MIL-M-28787/34B
AMENDMENT 2
16 December 1992
SUPERSEDING
AMENDMENT 1
24 April 1984

MODULES, STANDARD ELECTRONIC

MULTIVIBRATOR, MONOSTABLE, DIGITAL, KEY CODE JBN

FIGURE 13. Power supply current test circuit for table IX.

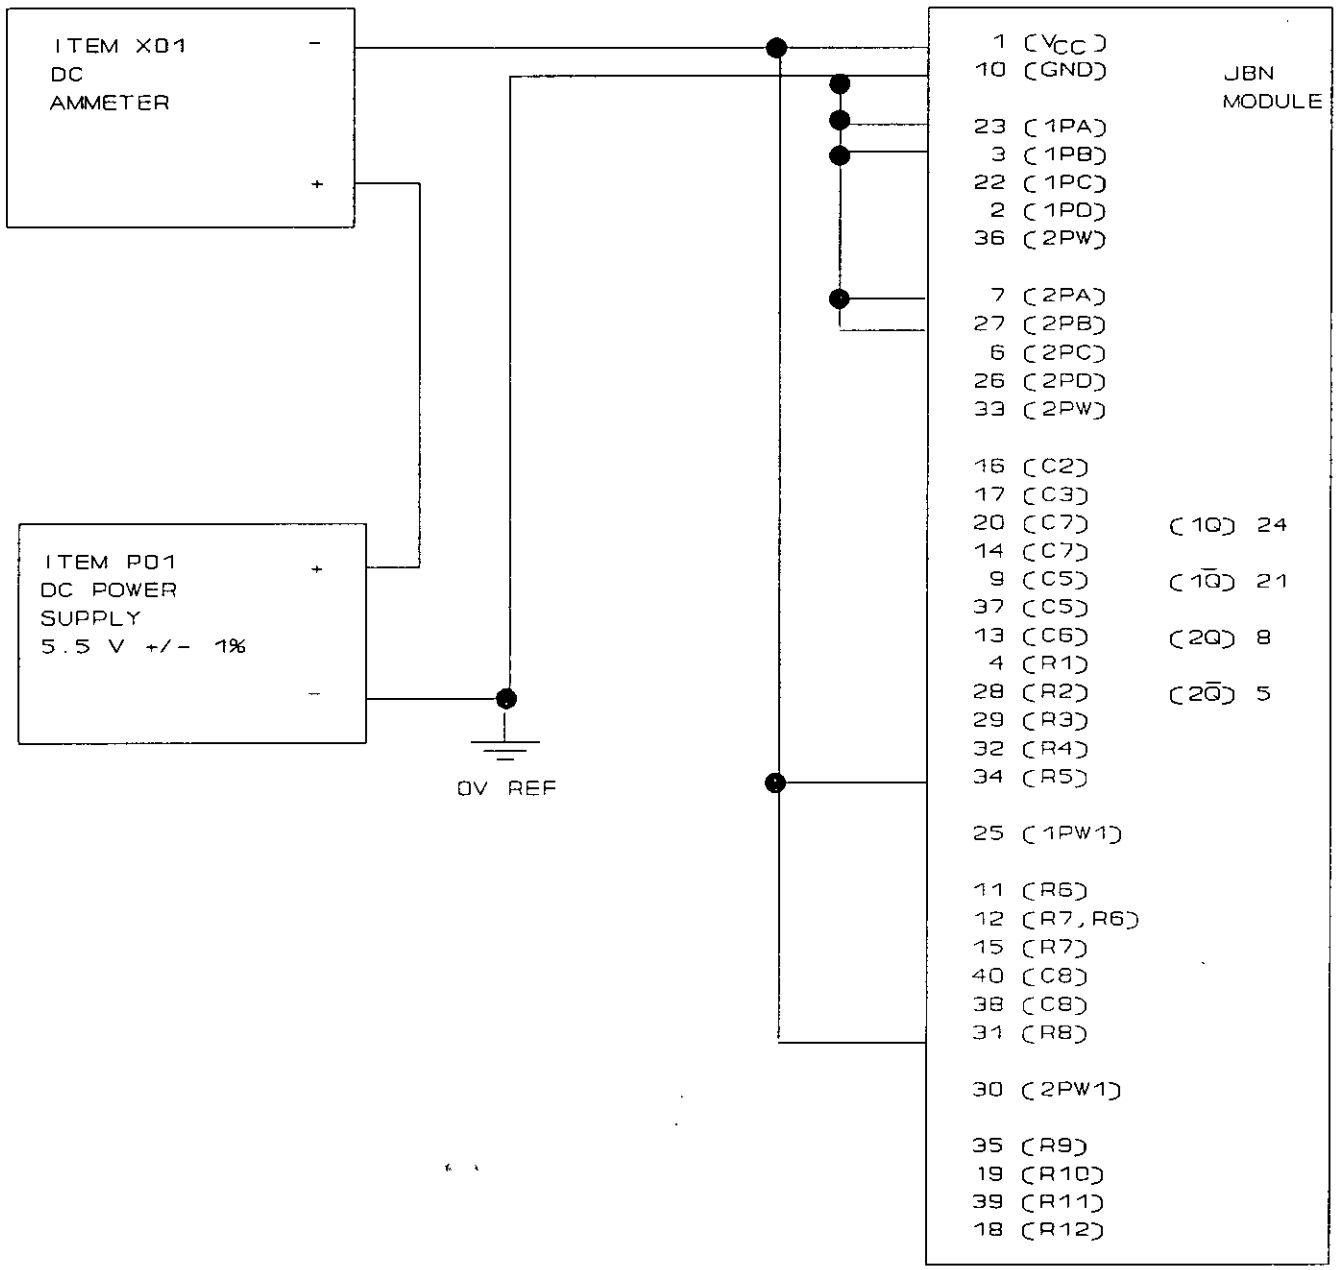
*FIGURE 13: Delete and substitute new figure 13 as printed on page 15 of this amendment.

CAUTION: Do not isolate the chassis of ammeter X01 from earth ground.
